SUB-COMMITTEE ON SHIP SYSTEMS AND
EQUIPMENT
5th session
Agenda item 12

SSE 5/12/3
3 January 2018
Original: ENGLISH

**UNIFIED INTERPRETATION OF PROVISIONS OF IMO SAFETY, SECURITY AND
ENVIRONMENT-RELATED CONVENTIONS**

Fire detection and alarms for boilers in periodically unattended machinery spaces

Figure 1: Example of auxiliary composite boiler

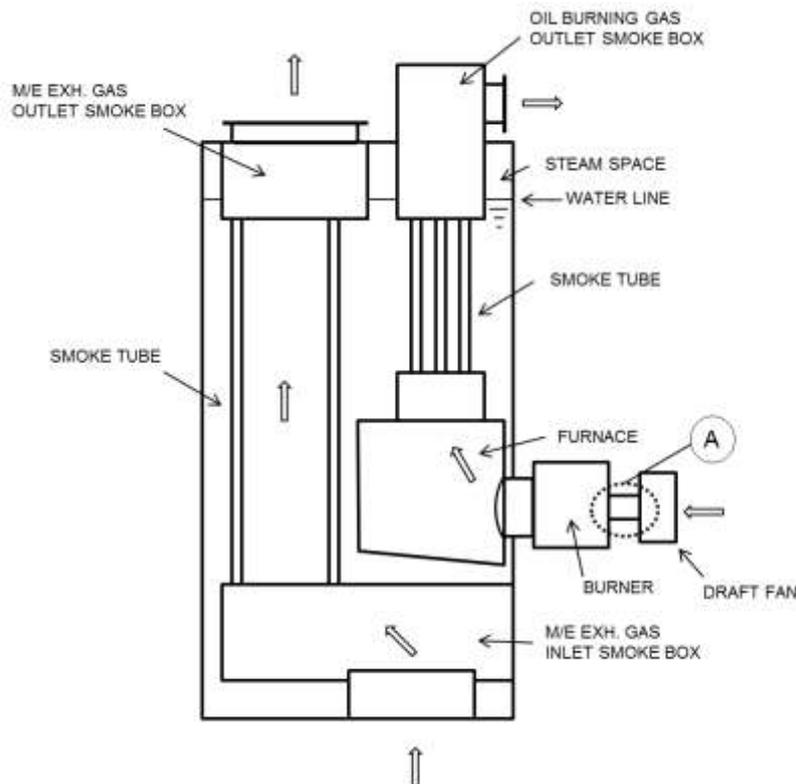
4 This regulation appears to imply that fires are equally likely to occur in both air supply casings and exhausts (uptakes). In the view of IACS this assumption may not be accurate. The main cause of fires is the accumulation of oily soot on surfaces in way of the hot gas flow. Only surfaces in the hot gas flow have such inherent fire risk. For example, in an auxiliary composite boiler, such as the one shown in figure 1 below, the duct from the draft fan to the burner (see "A" in figure 1 below) is considered to correspond to "air supply casings", but there is no reason to expect that fires will occur at such locations. Therefore, it is considered that this location should not be subject to the provisions of SOLAS regulation II-1/47.1.

It is considered that only boilers with an inherent fire risk should be subject to the provisions of this regulation and, in this context:

- .1 "inherent fire risk in the air supply casing" means a fire risk that is introduced by heat exchangers, e.g. rotary heat exchangers, having surfaces exposed alternately to air and flue gas; and
- .2 "inherent fire risk in the flue gas uptake" means boilers where there is a possibility of accumulation of oily soot on surfaces in way of the hot gas flow.
